Environmental Review Team Report
Loveland Road Recreation Area
Hebron, Connecticut

Environmental Review Team
Report

Loveland Road
Recreation Area

January 1984

Proposed Development Plan

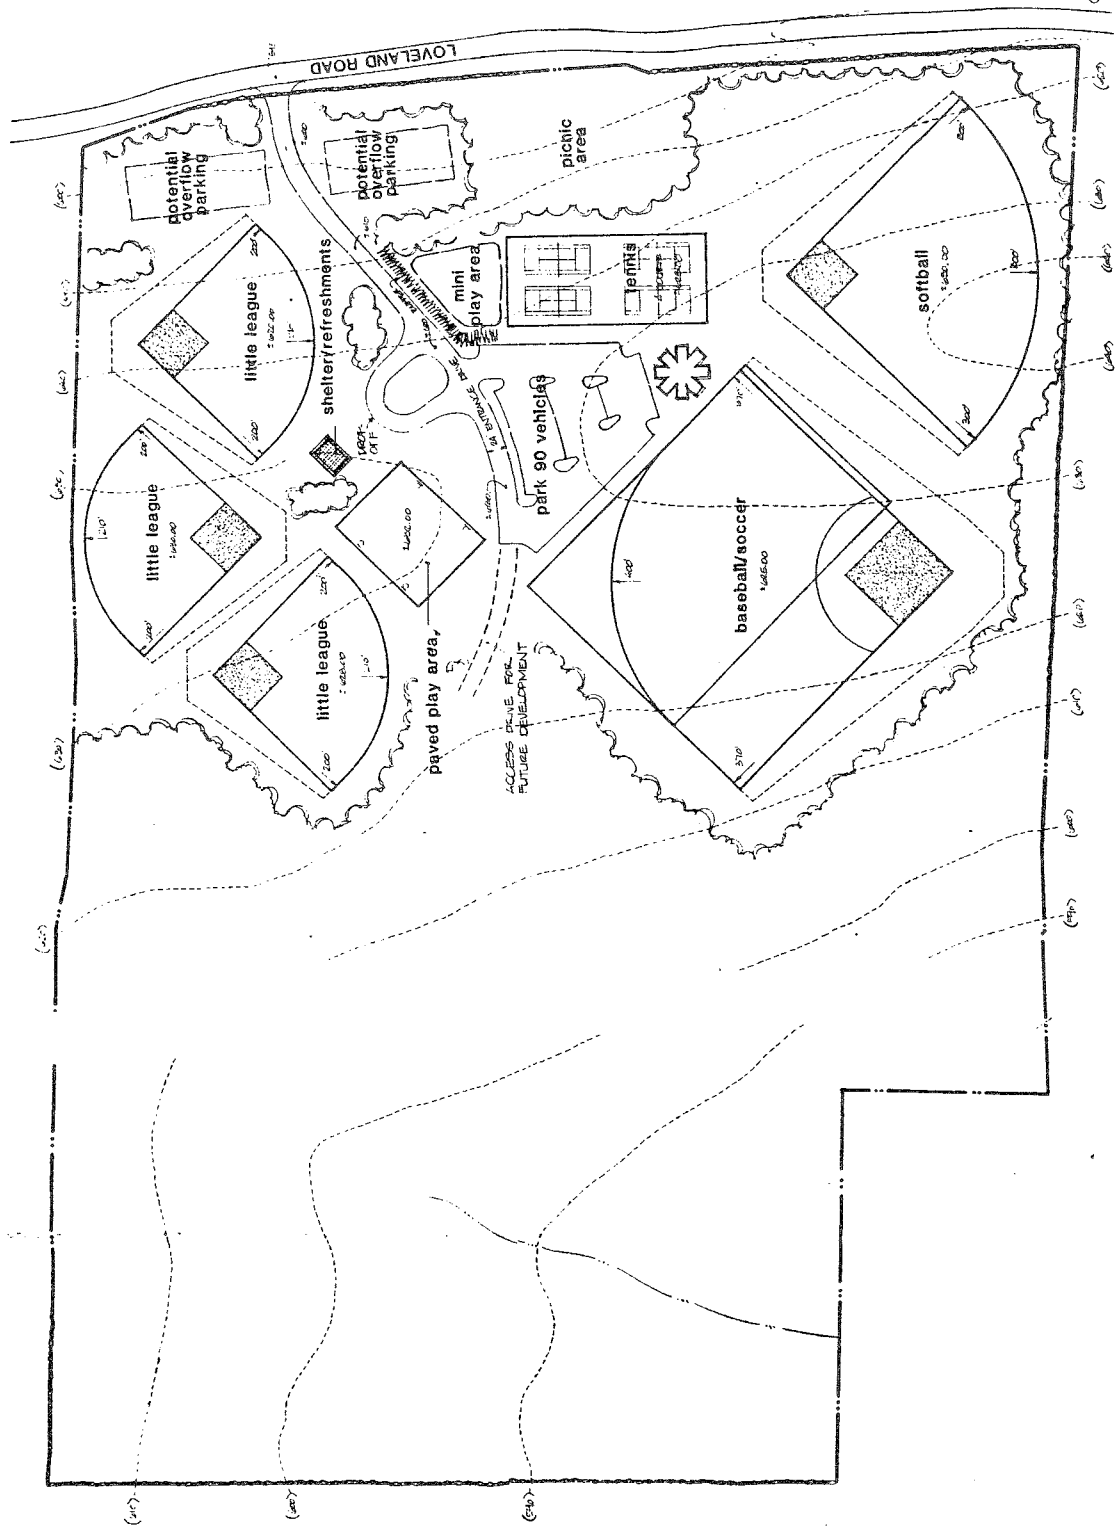
1. Too many facilities have been planned on an inadequate amount of land space. The facility appears crowded and congested with athletic facilities leaving minimal open space for passive recreation and enjoyment.

2. The concentration and proximity of the three (3) little league fields pose a serious threat to the safety of spectators and pedestrians from foul line drives and fly balls.

3. The access road leading to the middle of the park and the placement of the parking lot should be carefully reviewed. The access road, with cars, motorcycles and bicycles, will create serious safety hazards for all park users, particularly small children. Placement of the parking lot along the property fronting Loveland Road would eliminate this problem.

4. Parking facilities should be re-evaluated to provide adequate parking to handle peak park use. Ninety (90) parking spaces would be inadequate during peak use.

5. Extensive improvements will need to be made to Loveland Road to handle the traffic that the park will generate.
6. The Town should consider and prepare for the necessary financial commitment to operate and maintain the facility.
